FINAL REPORT

AN/SPS-57 RADAR IMPROVEMENT PROGRAM, PHASE II

February 1977

FIELD CHANGE TO THE  
AN/SPS-57/57X RADAR SET

Figure 1. ANTENNA ASSEMBLY (IAL)

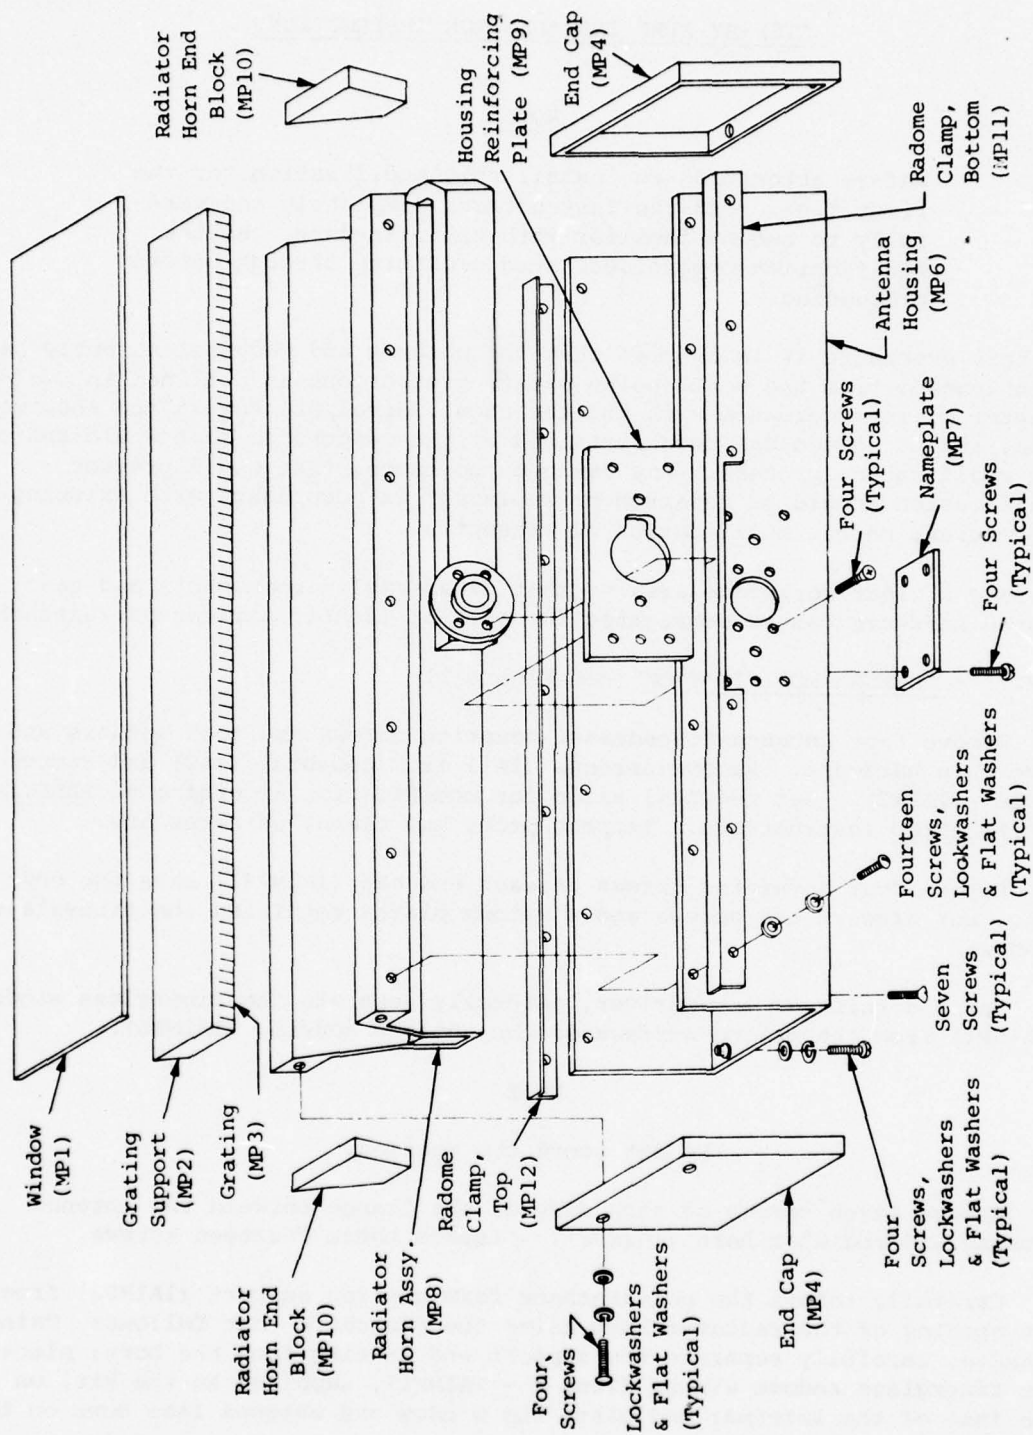
### PART I - ANTENNA MODIFICATION (see Figure 1)

1. Remove five antenna-to-pedestal mounting screws and lock washers and save this hardware. Remove antenna (1A1) from pedestal (1A2) and remove probe (1A2W2). Set pedestal aside for modification according to PEDESTAL MODIFICATION instructions. Inspect probe and clean, as necessary.
2. Remove four retaining screws on each end cap (1A1MP4); save the end caps, but discard the screws and aluminum plates retaining the fiberglass window.
3. Using a knife or screwdriver, carefully separate the fiberglass window (1A1MP1) from the mating surface of the antenna housing (1A1MP6).

4. Remove seven screws on each side of the flange between the antenna housing and radiator horn (1A1MP8). Discard these fourteen screws.
5. Carefully remove the polyurethane foam grating support (1A1MP2) from the opening of the radiator horn, using the procedure that follows: Using a knife, carefully separate the support and grating from the horn; place the fiberglass radome window (Item 8 - 1A1MP1), supplied in the kit, on the face of the antenna; and place the window and antenna face down on the

work surface. Lift the antenna off of the window, tapping the assembly lightly to separate the radiator horn from the foam grating support. (This support is slotted on the horn mating surface and can be easily broken.) Extreme care is necessary in removal and handling. Care should also be exercised in retaining the metal grating plates (1A1MP3) embedded in the slots. Remove grating plates and clean all parts with fresh water, blow dry with compressed air, flush with Inhibisol or equivalent cleaning solvent, and redry with compressed air.

Figure 2. ANTENNA PEDESTAL ASSEMBLY (1A2)

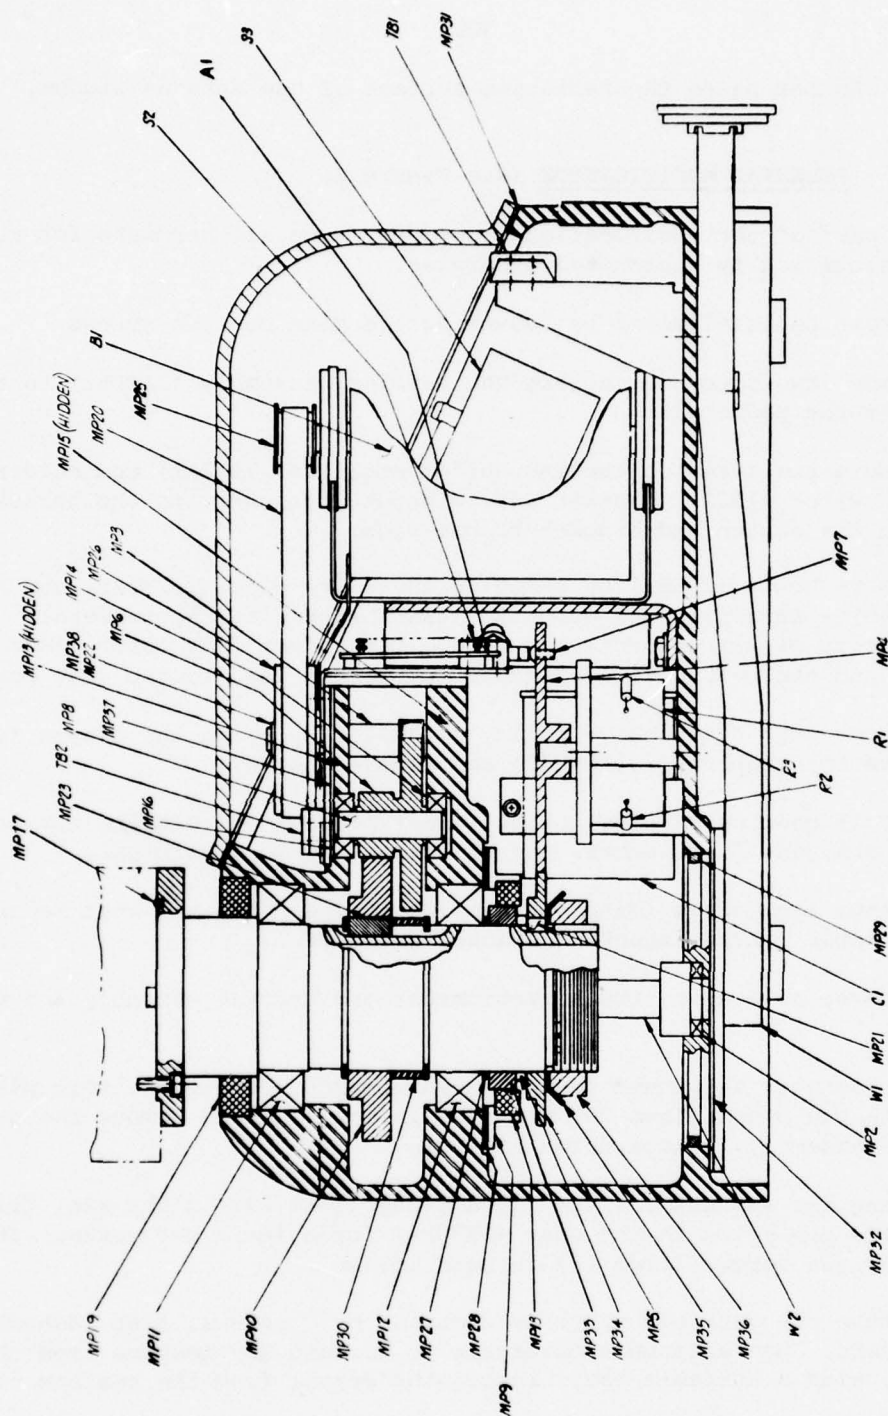
PART II - PEDESTAL MODIFICATION (see Figure 2)

1. Remove pedestal cover by loosening the nine captive screws.
2. Remove two screws attaching the terminal assembly (1A2TB1) to the bottom of the pedestal.

3. Remove two screws attaching buffer amplifier (1A2A1) and heading flasher switch (1A2S2) bracket and, without disconnecting the harness, position the switch and bracket to one side.

4. Remove Motor (1A2B1) by removing the drive belt (1A2MP20) and three 1/2-20 bolts attaching the motor mounting bracket to the pedestal. Record the identity of the connection points. Disconnect four motor leads from 1A2TB1, and the 6-32 screw attaching the ground lead to the gear box cover.

9. If the gear is pinned to the potentiometer, remove the roll pin by using the pin punch (Item 20) provided in the kit, and remove the gear from the assembly. Discard the roll pin.

Figure 5-2A. ANTENNA ASSEMBLY

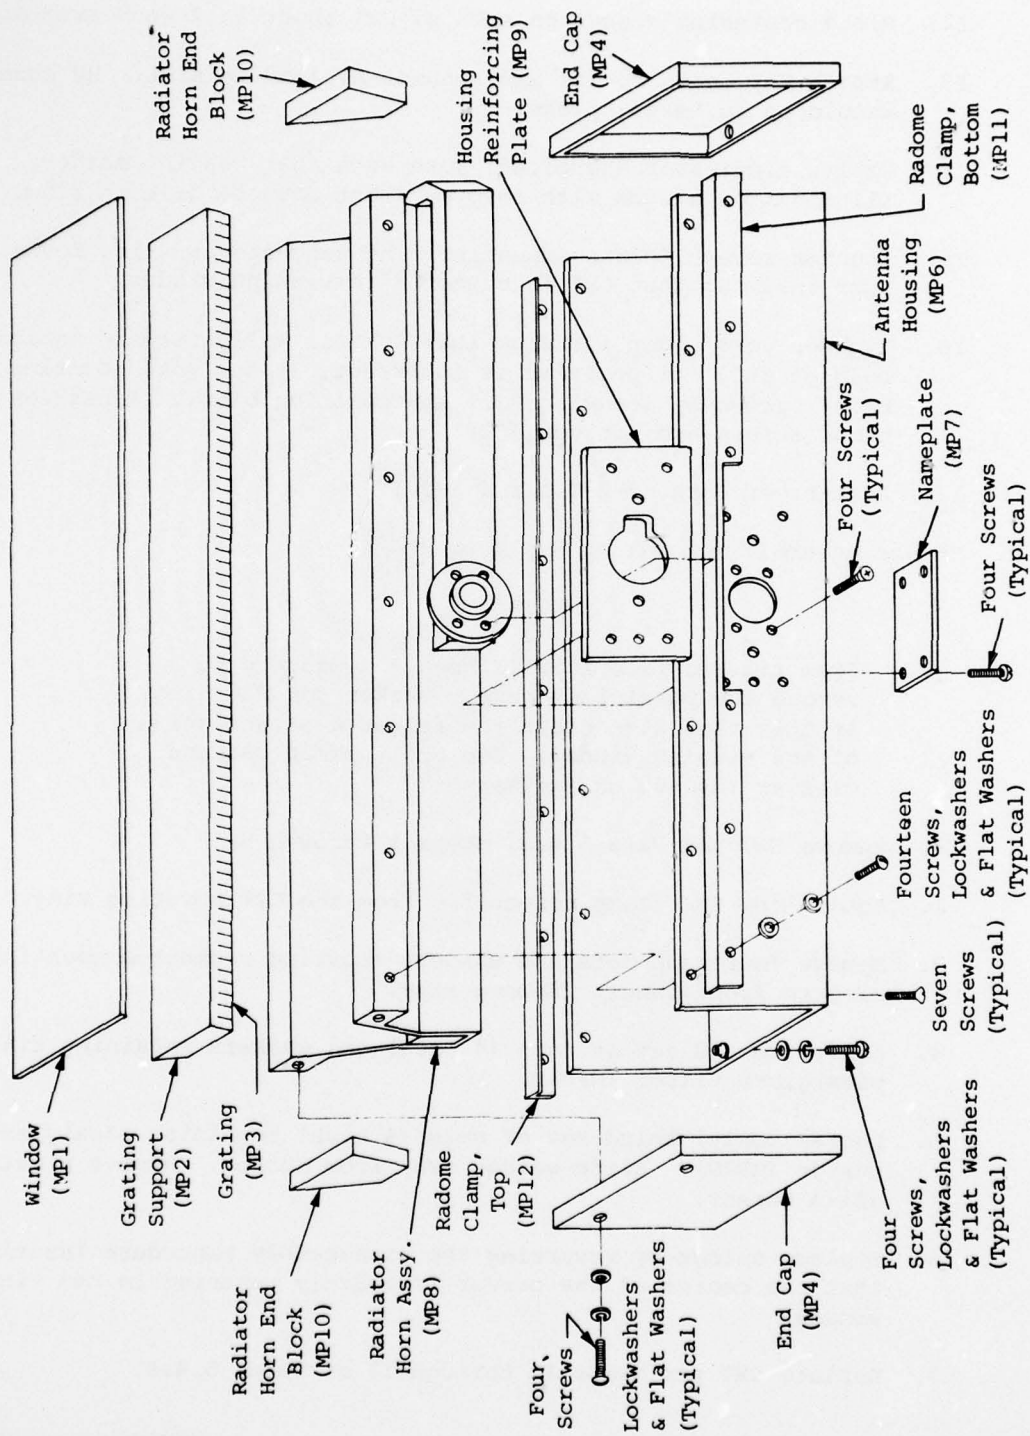
Page iii - change reference from Figure 5-2. Antenna Pedestal Assembly, on page 5-19/20, to Figure 5-2B. Pedestal Assembly, on page 5-19/5-20.  
- Add reference Figure 5-2A. Antenna Assembly, page 5-19.

This procedure describes the complete process for antenna disassembly and reassembly. Maintenance actions involving specific components will require only those steps necessary to replace the component. Specific supplementary information is provided in the sections dealing with those components. See Figure 5-2A for component location.

Figure 5-2B Antenna Pedestal Assembly. (1A2)

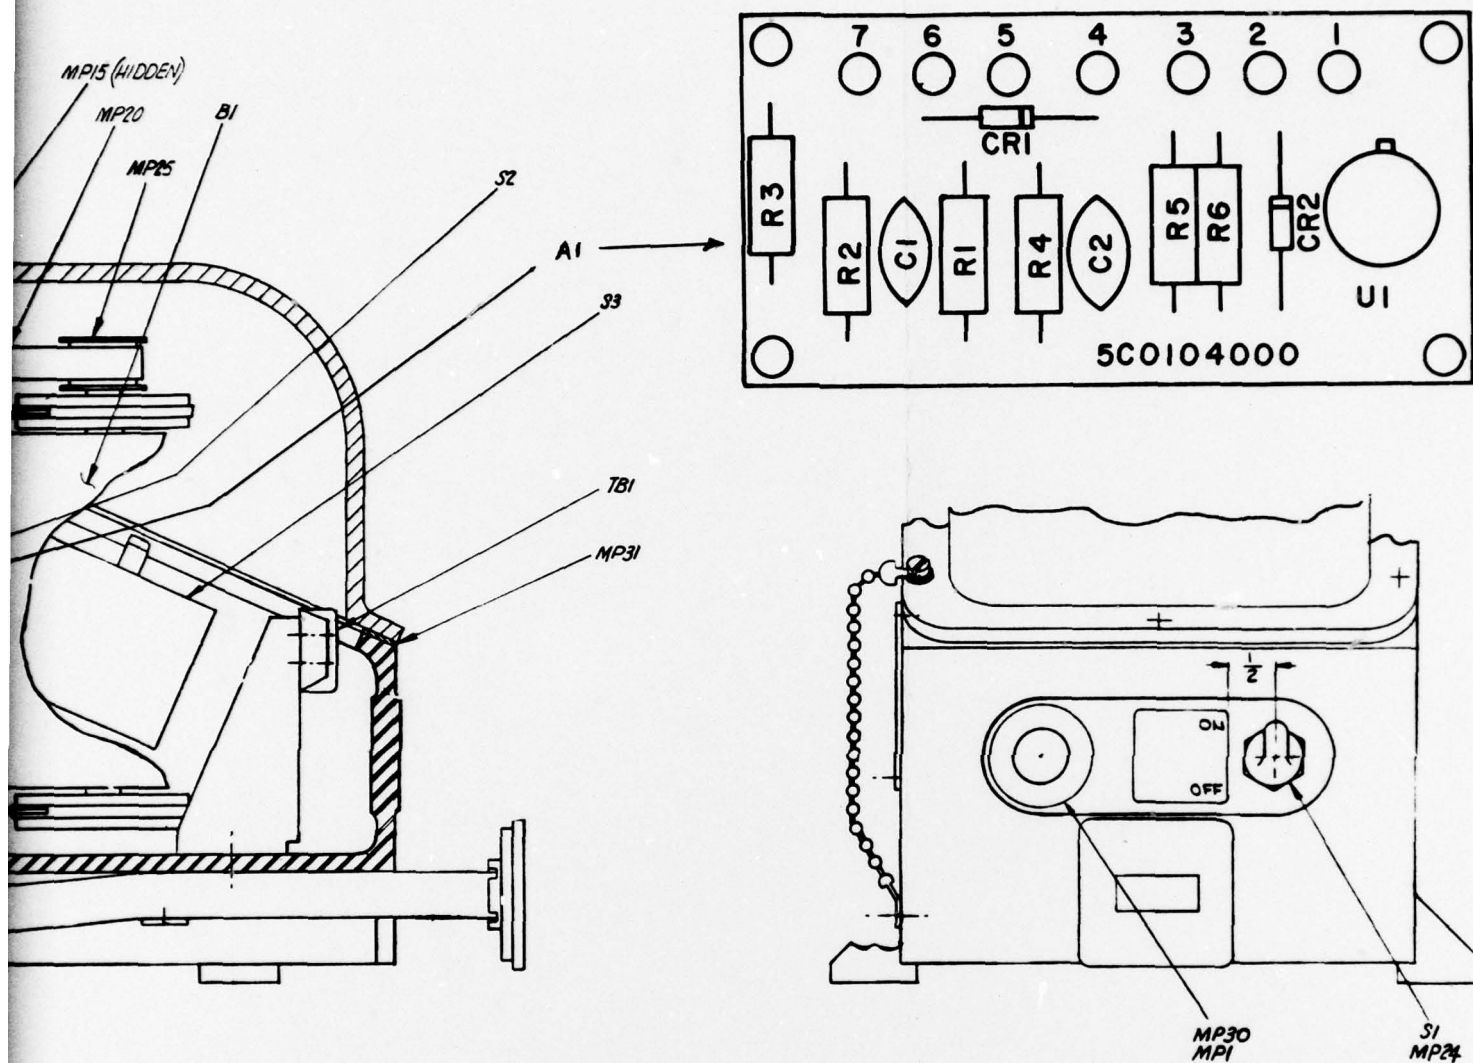
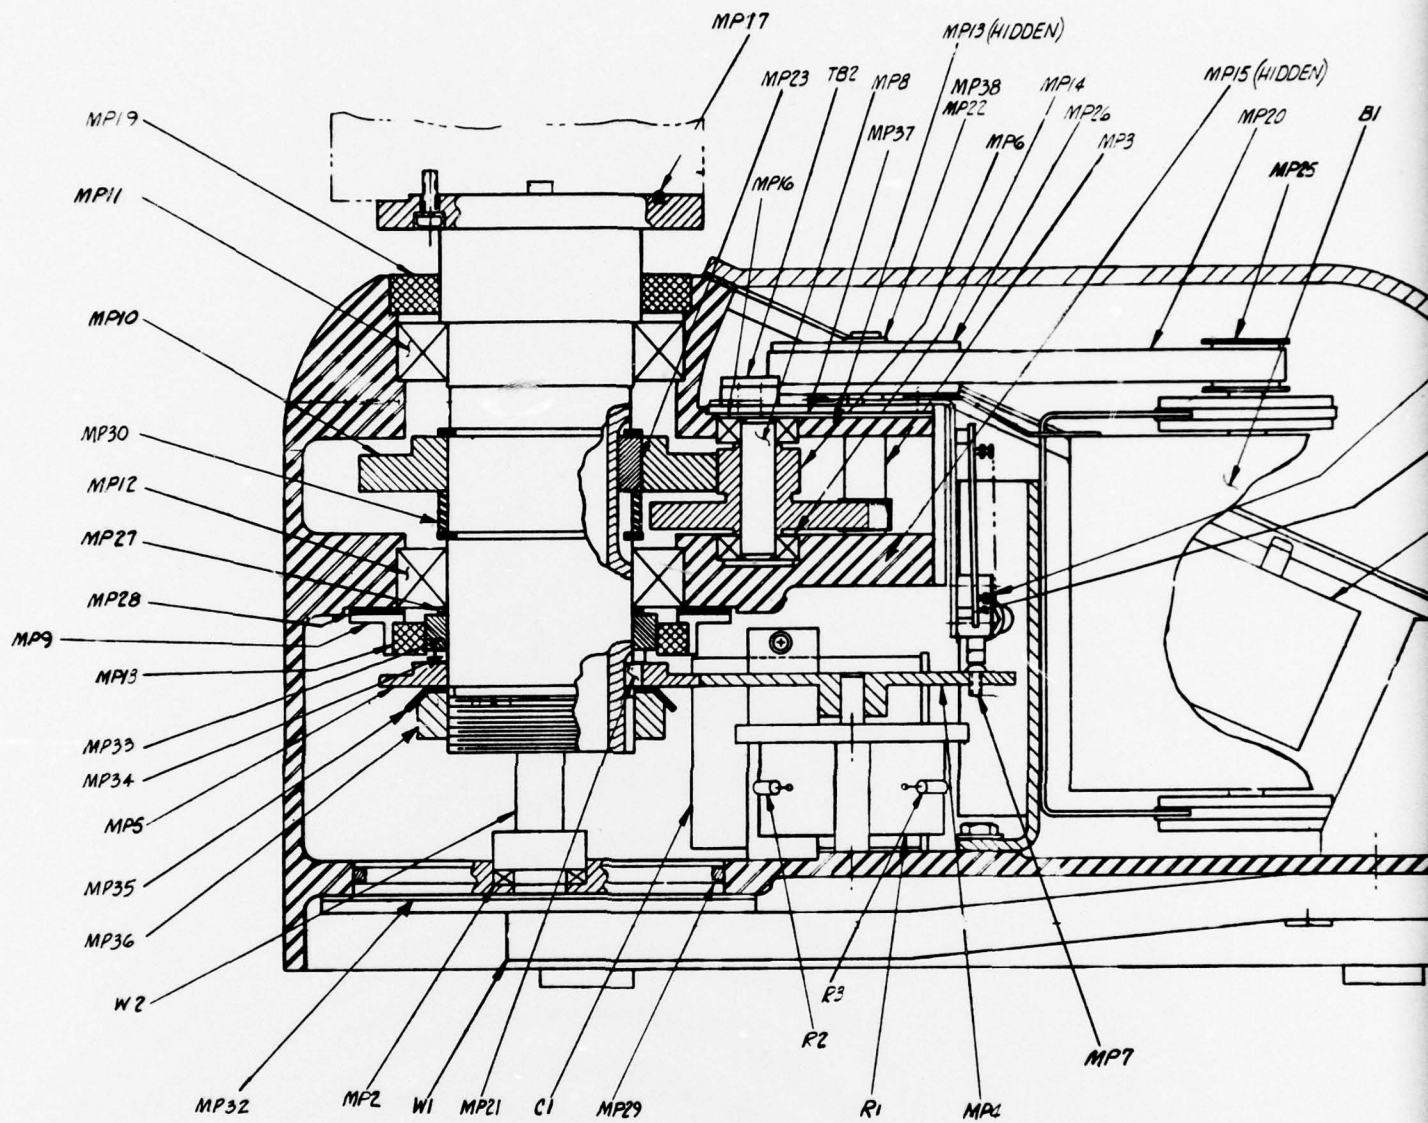
5-2-3 Antenna/Pedestal (see Figure 5-2B)

- A. Antenna Gear Train (annually or when excessive gear train noises are noted) (see Figure 5-2B).
  1. Perform steps 1 through 10 of para. 5-4 and steps 1 through 10 of para. 5-4-A2.
  2. If the antenna is noisy or bearing failure is evident from the inspection, proceed with appropriate subsequent steps. Otherwise, proceed to step 35 of para. 5-4-A2 and continue with reassembly.

This procedure describes the complete process for pedestal disassembly and reassembly. Maintenance actions involving specific components will reference the applicable general sections that follow for removal and replacement, with specific supplementary information provided when required in the section for that component. Refer to Figure 5-2B for component location.

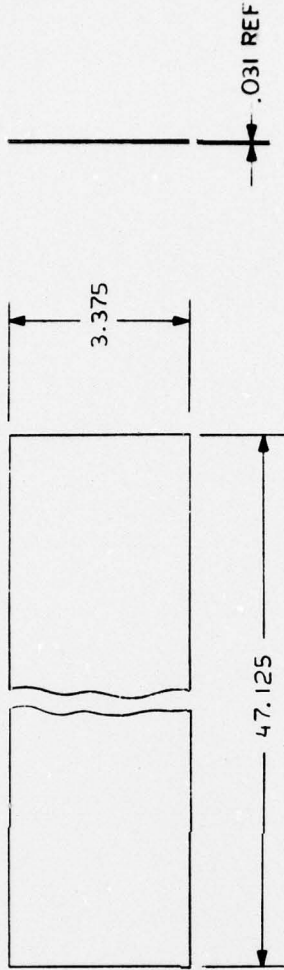
REVISIONS			
SYM	ZONE	DESCRIPTION	DATE
A		ZONE C-6, DIM 47 7/32 WAS 47 1/4 ; ADDED NOTE 3. (CN462)	5/18/73
B	C6	IN MTL BLOCK REMVD MOLDED .025 THK; ADDED INDICATION OF FRONT SURFACE ADDED CONSTRUCTION DETAIL; REVISED NOTE 3; ADDED NOTES 4, 5 & 6. (CN463)	5/22/73
C		REDRAWN; CHANGED DIM & DWG SIZE	7/17/76
